Change 1 from NIC's new file 20220301:
The position for SD is longer
----- OK ,no problem from Hasion 3.1

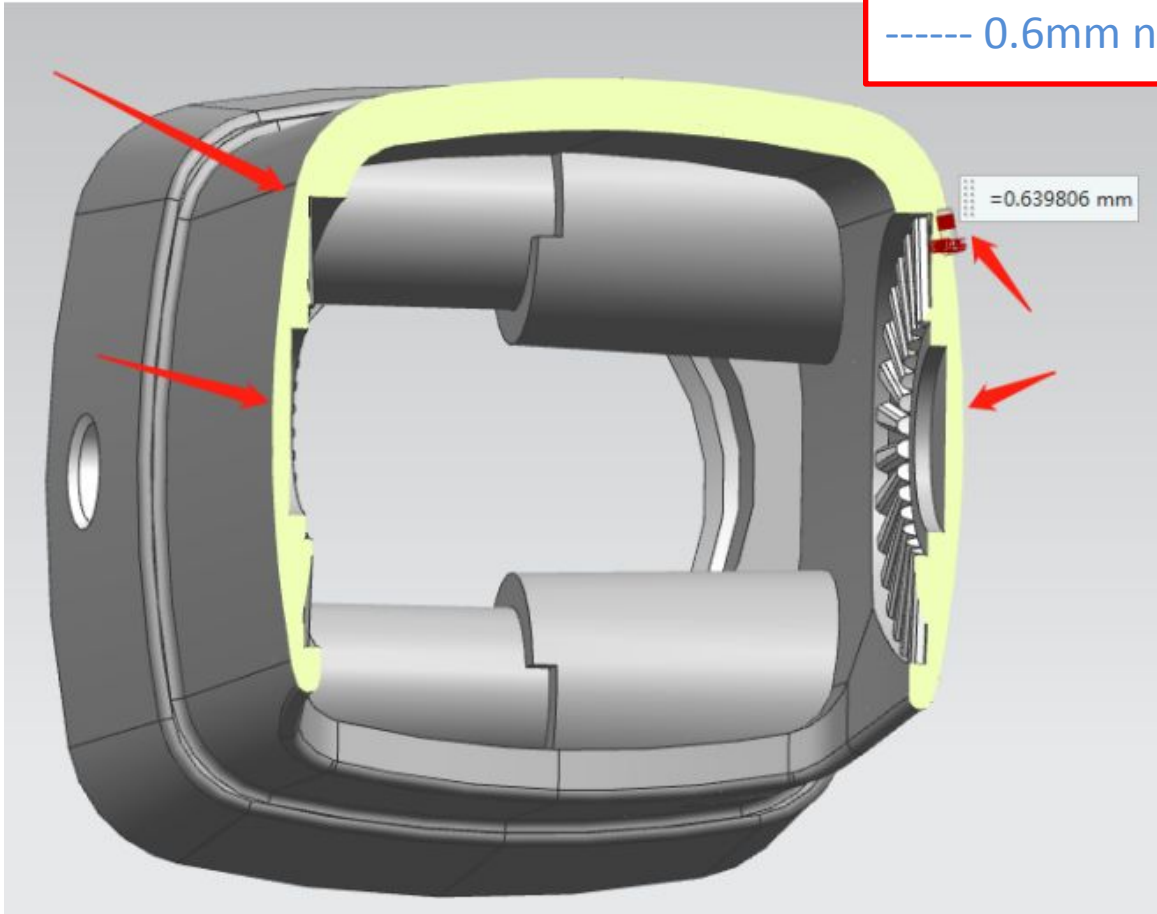
Change 2 from NIC's new file 20220301:
The position for gear
----- OK ,no problem from Hasion 3.1

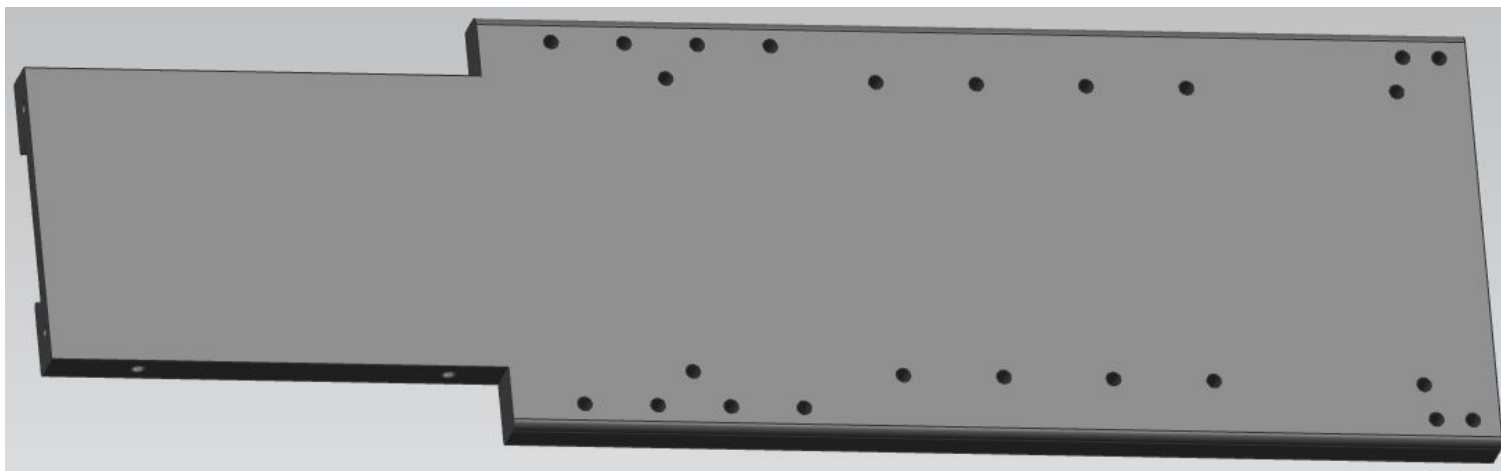
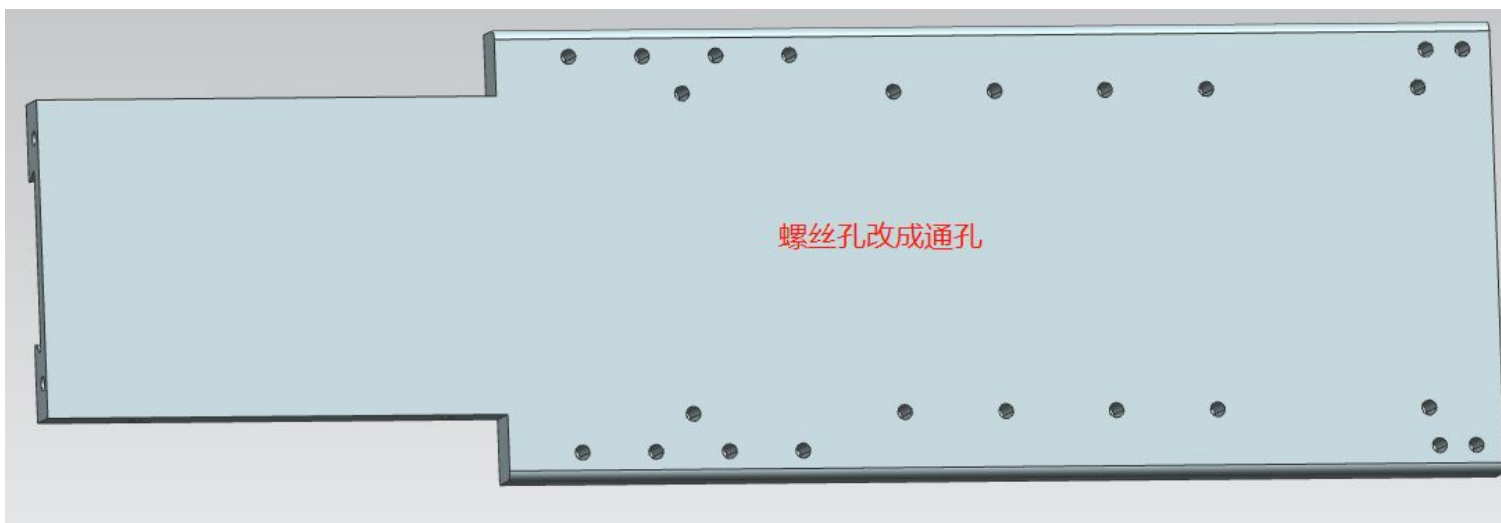
Change 3 from NIC's new file 20220301:

The thickness for here position

----- 0.6mm not OK , It at least 1.2mm--Hasion.3.1

because only 0.6mm thickness ,
too thin , easy to be broken

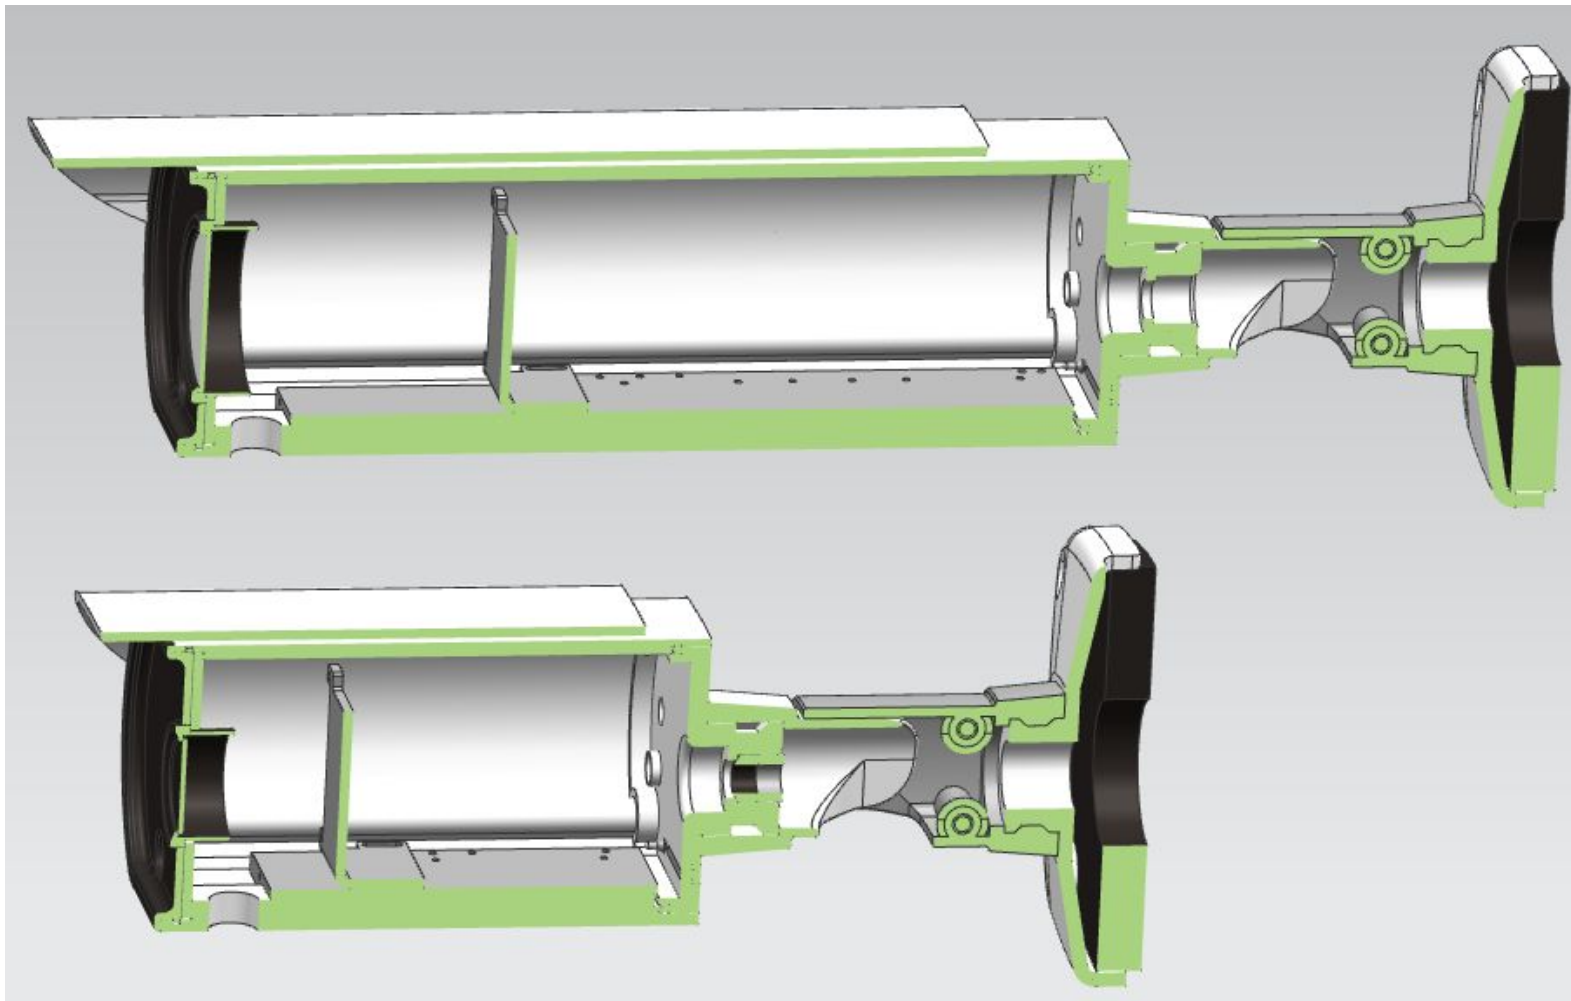
Change 4 from NIC's new file 20220301:
the hole is through hole type

Problem 5 from NIC's new file 20220301:
fixing way of the bracket board

-----the fixing way is not unreasonable, it doesn't improve the fixing --
Hasion 3.1
